East Hyde, Not Duly Made Request for Further Information- 15th March

Project name: STC IED Temple Quay, Bristol,

Project no: B22849AZ BS2 0ZX

Document no: C.240328-8

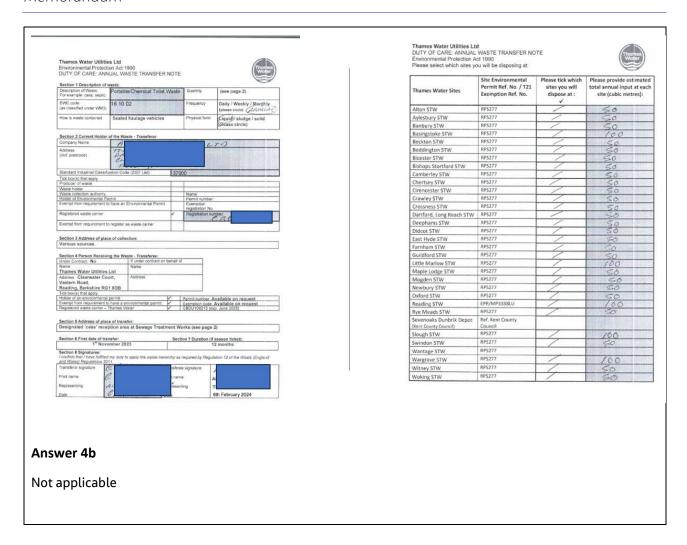
- 4. Table B3 1b (ii) Waste accepted at the head of the works import point.
- a. Provide transfer notes to demonstrate that the wastes requested are already accepted on the site.; or if waste is not currently accepted.
- b. Provide an assessment of the fate an impact of the substances emitted to water from this activity following the Environment Agencies <u>risk assessment guidance</u> in line with relevant guidance (https://www.gov.uk/guidance/non-hazardous-and-inert-waste-appropriate-measures-for-permitted-facilities/6-emissions-control)

Answer 4a

Please find below an example Portable Toilet Waste, Annual Waste Transfer Note and on page 2 confirmation East Hyde STW is a TWUL site used by the customer. Note: customer details redacted solely for the purpose of this response.
